| Project Title: | SJ2 |
| Document Title: | Report of Conversation- K Garrison, USFWS and C Watson, CEC- March 25, 2021 |

| PROJECT TITLE: San Jose Data Center | | Docket: 19-SPPE-04 |
| SUBJECT: CDFW Notice of Preparation Comment Letter and other Biological Issues | | |

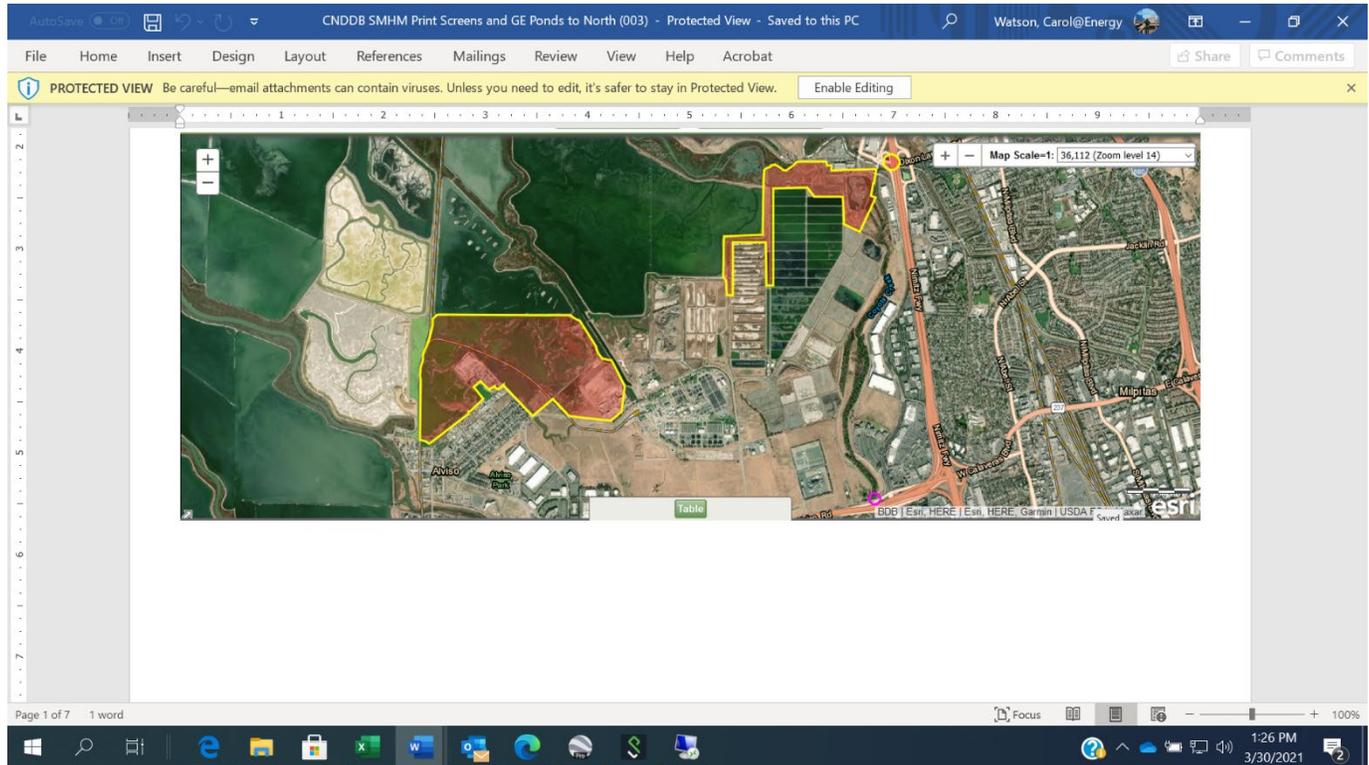
Salt marsh harvest mouse: this species was dismissed from further consideration within the SPPE application. CNDDDB shows salt marsh harvest mouse occurrences in two distinct salt marsh habitats to the north of the site (see map below; salt marsh outlined in yellow). Potentially suitable habitat for salt marsh harvest mouse may exist between these CNDDDB locations and wetlands (detention ponds) immediately adjacent to the northern end of the project site (general approximation of the southern end of the project site in pink), according to CDFW. It may be possible that, if present within these wetlands to the north of the project area, salt marsh harvest mouse could enter the project site or access route; as a fully protected species, no impacts may occur. CEC staff to investigate further and develop draft mitigation as necessary.

Map of Potential Salt Marsh Harvest Mouse Habitat, as provided by CDFW:

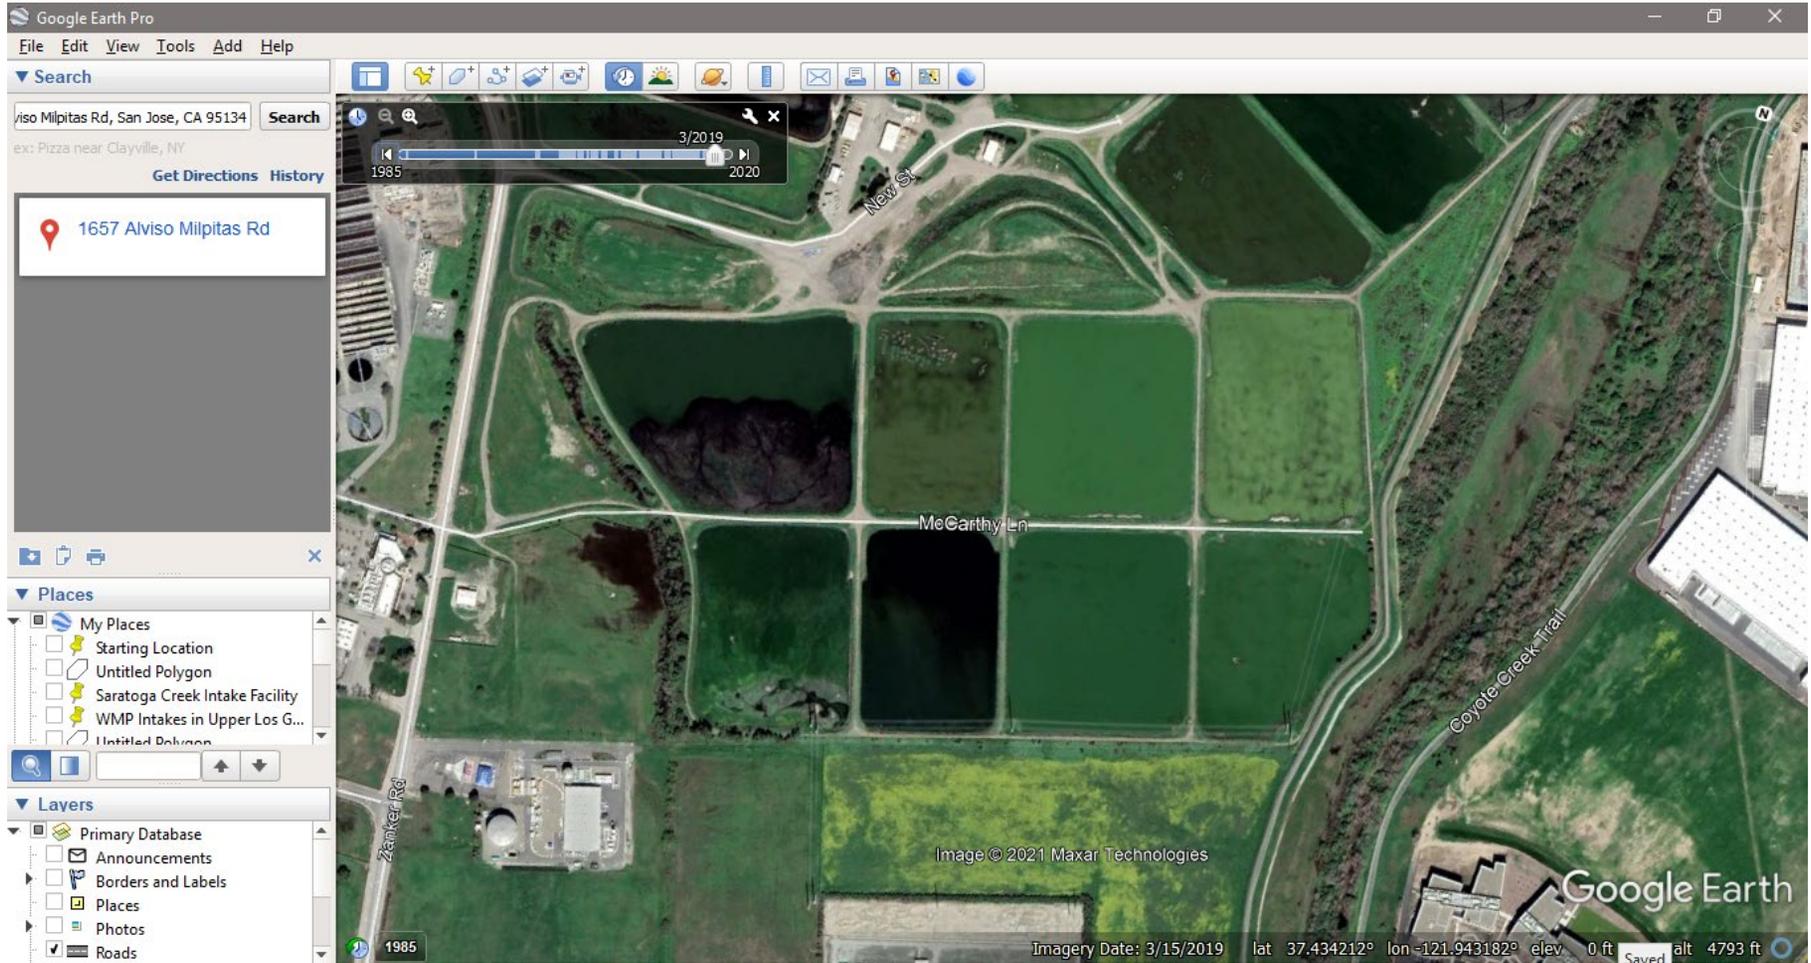
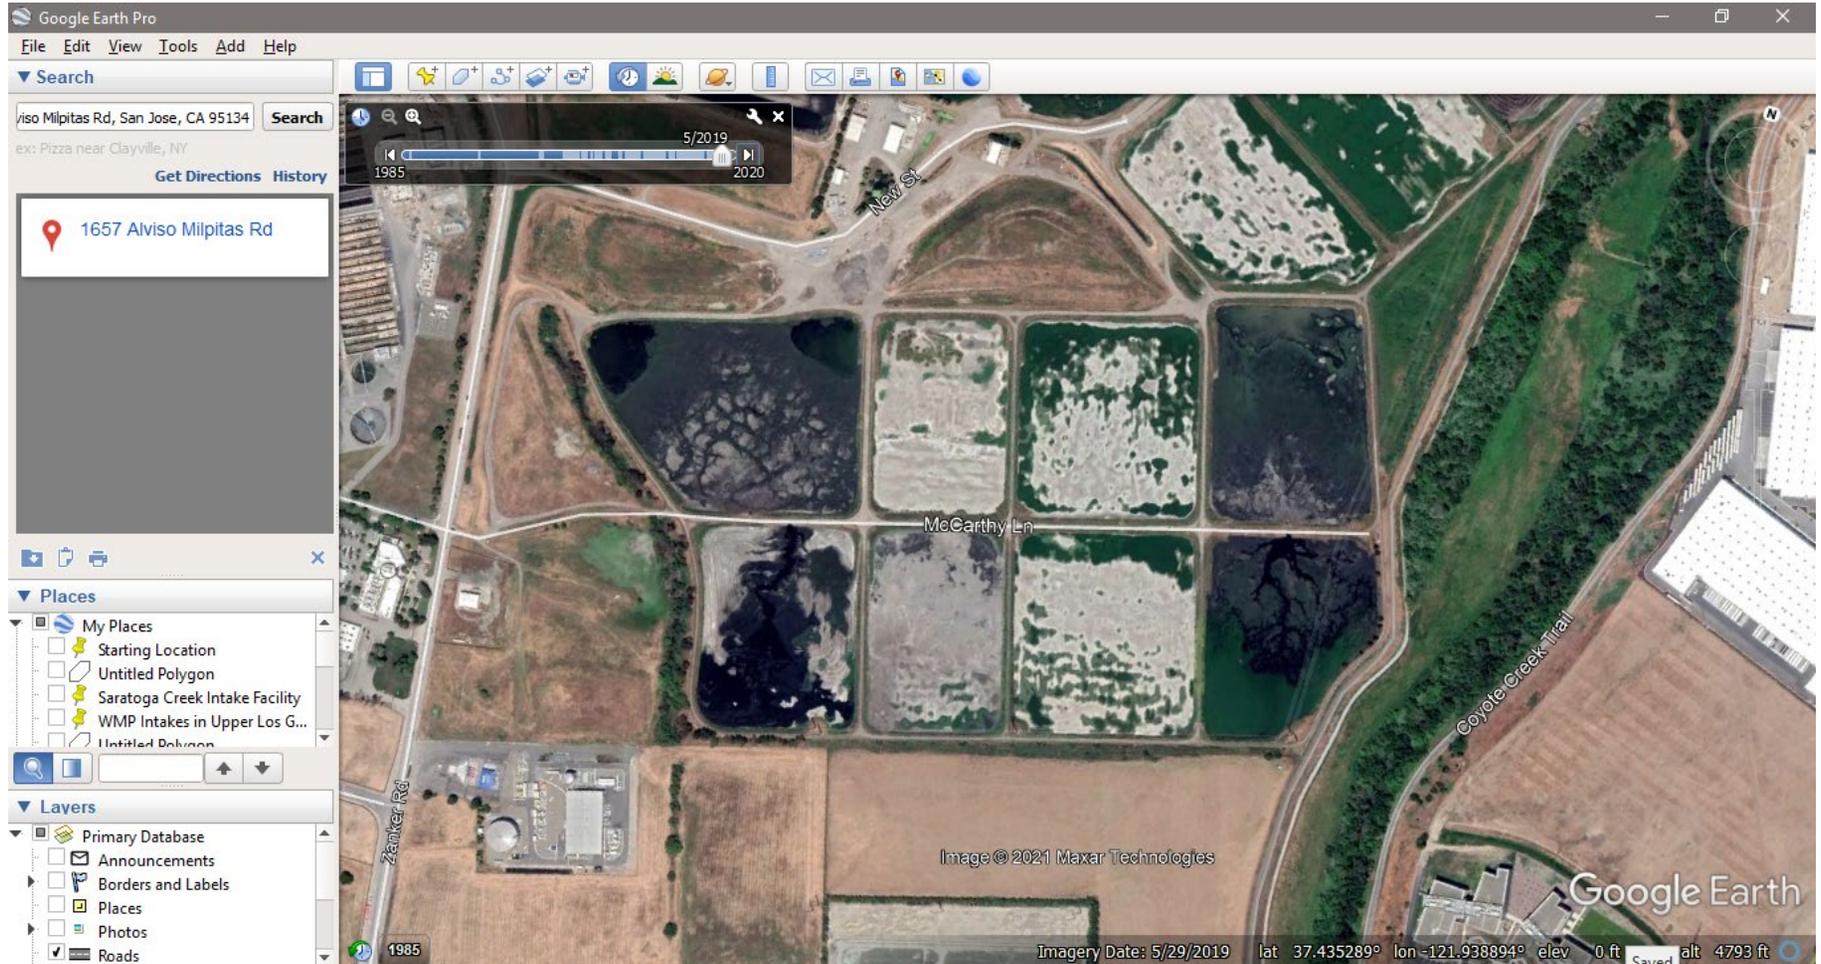
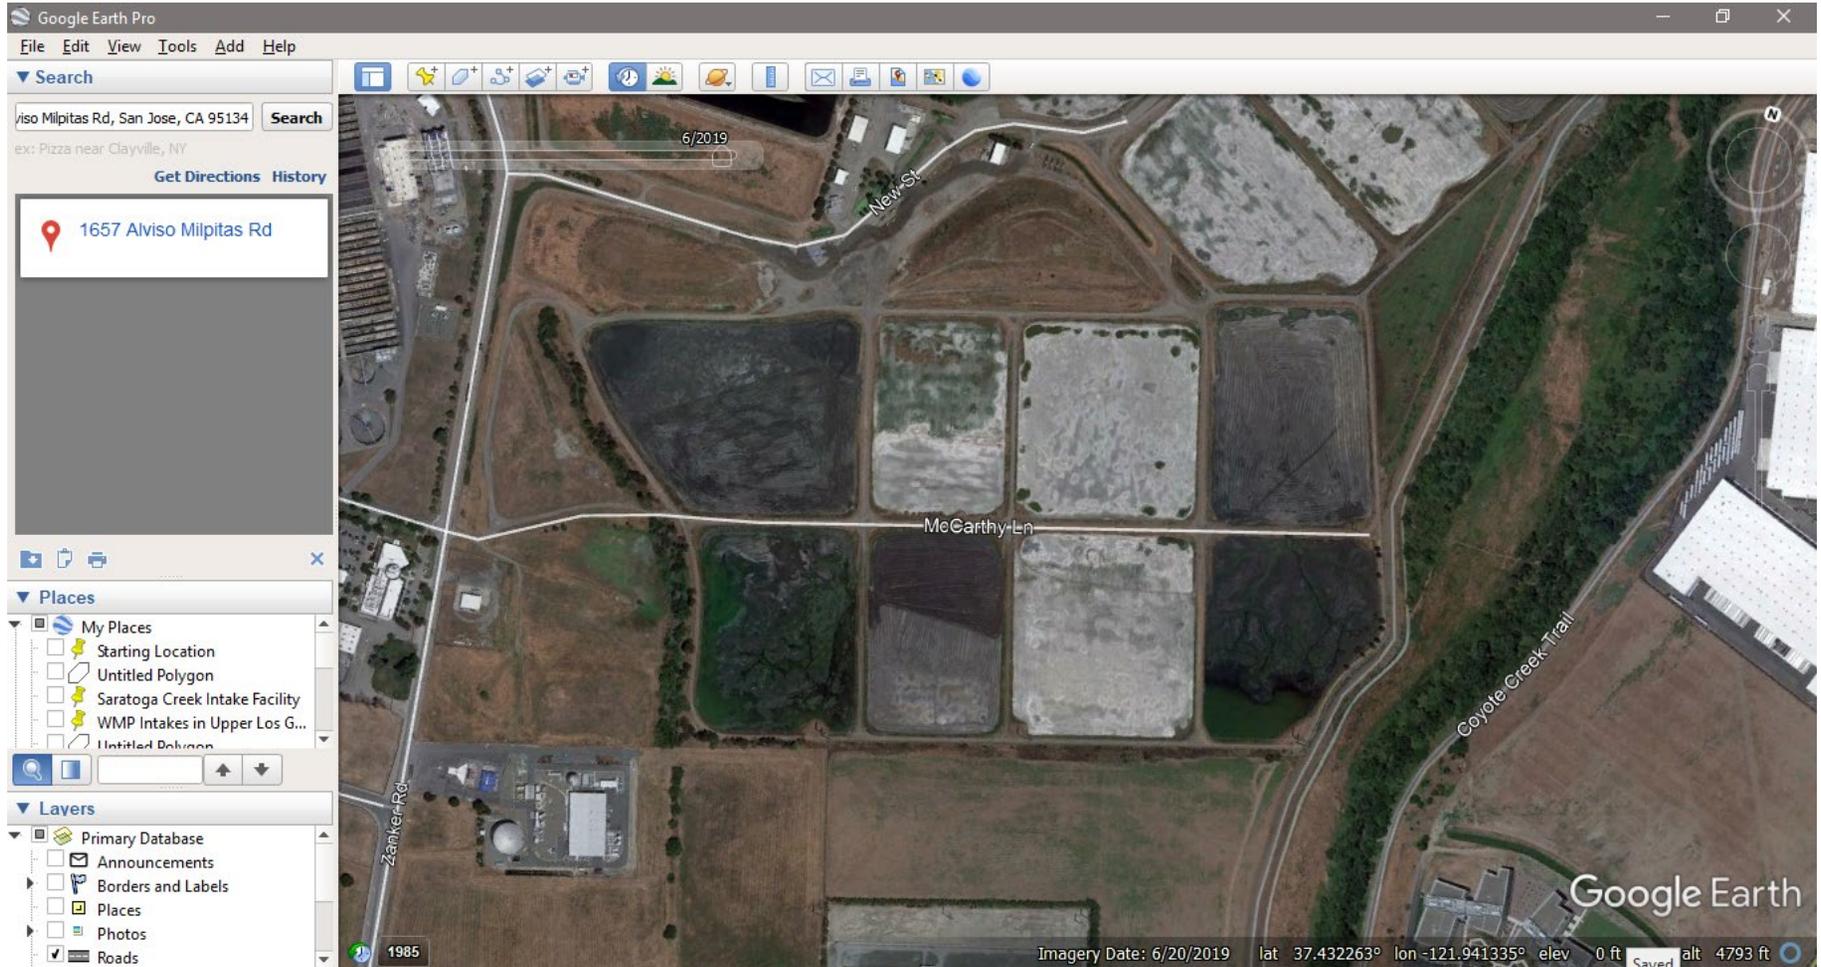
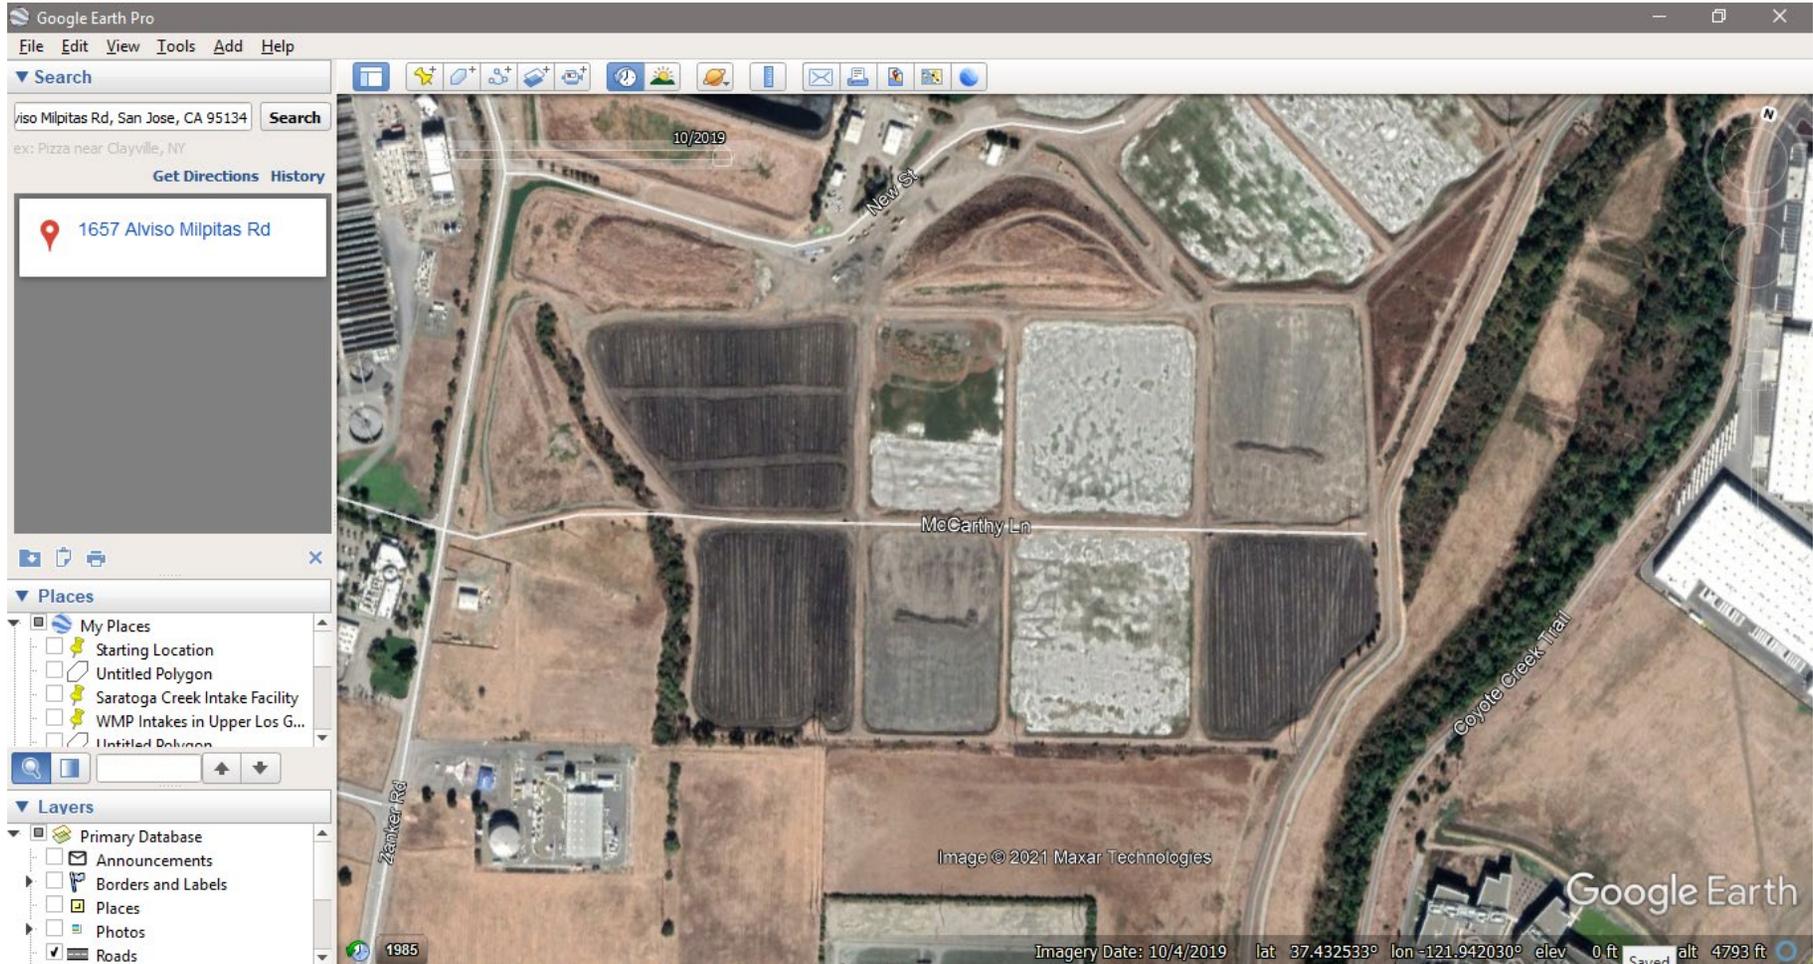
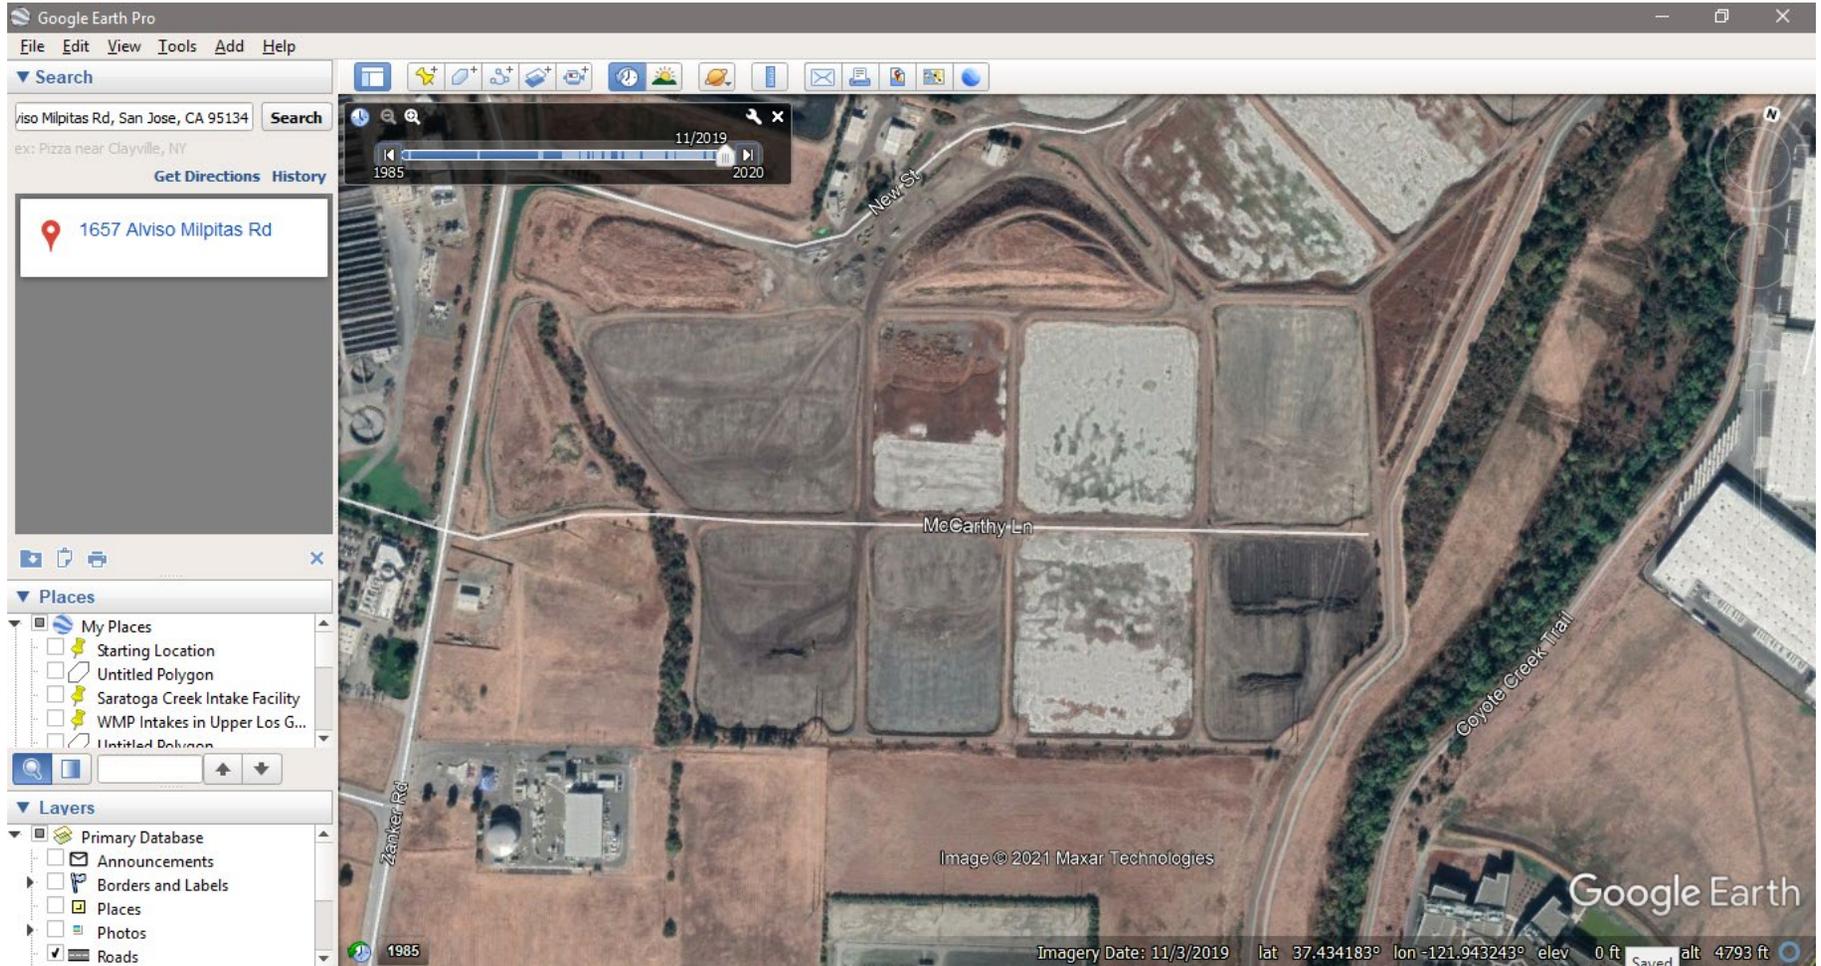
Regarding SMHM, this species is known to be present in tidal bay habitats (the presence of the CNDDDB occurrences support this) and also seasonal diked wetlands. Between those known habitats and CNDDDB occurrences and the project site, there are many, as you call them, "treatment ponds" that are contiguous with bay habitats from south San Francisco Bay to the northern border of the project site (see attached with a print screen of the CNDDDB occurrences and diked seasonal wetlands polygon I made using the measure tool). In looking at Google Earth aerials through time, it looks like the wetlands north of the project site have vegetation growth and other times they are mowed or maybe graded (print screens in the attached document). SMHM are not found in only pickleweed. There was an old study that had said this, but we now know that they are found in variable types of vegetation (see attached studies).

I am not saying this is highly suitable habitat. It may be marginal at best. However, we do need to be careful since they are fully protected and CESA endangered (and also ESA endangered). Maybe SMHM habitat is present to the north of the project site, maybe it is not. That is why a habitat survey is recommended, per my NOP letter. If habitat is not found, then avoidance measures are not needed.
